Commission for Energy Regulation

HVDC Interconnector Grid Code modifications

DOCUMENT TYPE:	Consultation Paper
REFERENCE:	CER/09/187
DATE PUBLISHED:	2 December 2009
CLOSING DATE:	14 January 2010
RESPONSES TO:	John Lynch (jlynch@cer.ie)

Appendix A.1: ABB Reactive Power Capability - 350MW Converter

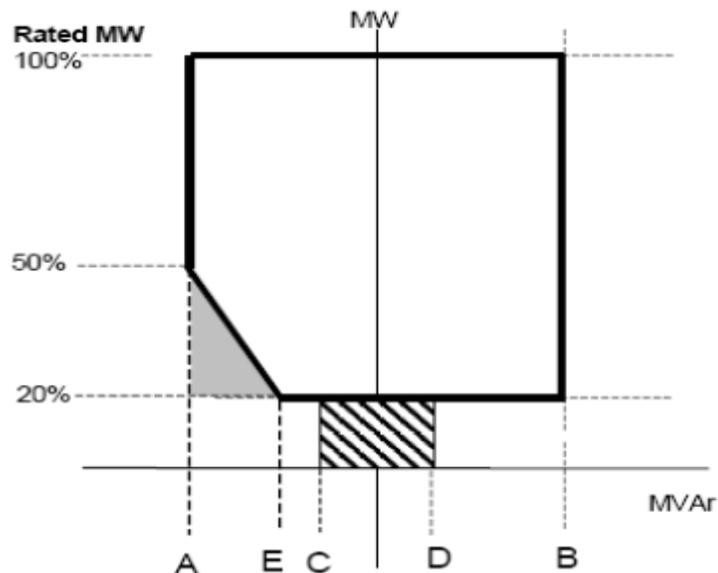
The current proposed requirement as it appears in the HVDC Interconnector Grid Code Modifications states that the HVDC Interconnector should be capable of operating in the region indicated below:

- Point A is equivalent (in MVar) to: 0.95 leading **Power Factor** at **Rated MW** output
- Point B is equivalent (in MVar) to: 0.95 lagging **Power Factor** at **Rated MW** output
- Point C is equivalent (in MVar) to: -5% of **Rated MW** output
- Point D is equivalent (in MVar) to: +5% of **Rated MW** output
- Point E is equivalent (in MVar) to: -12% of **Rated MW** output

Without additional reactive compensation, the ABB 350MW HVDC Interconnector will not be able to meet the proposed grid code requirement. ABB have informed the GCRP that the following reactive power requirements would be more suitable to the capabilities of their converter:

- 0.95 lead and 0.95 lag at 90% of the active power
- 99% lead and 99% lag at rated active power

Appendix A.2: ABB 350MW HVDC Interconnector Reactive Power Capability Diagram (Generator)

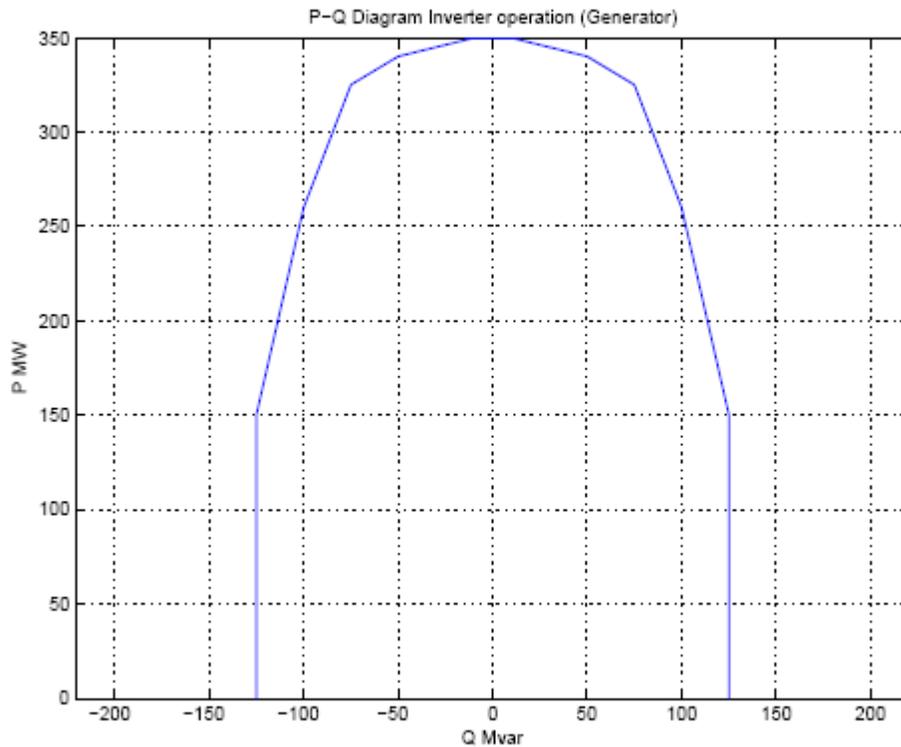
The diagrams in Appendix A.2 and A.3 represent the reactive power capability of the ABB 350MW HVDC Interconnector technology which is planned to be used for the Templeraíney Interconnector connecting to Arklow 220kV substation.
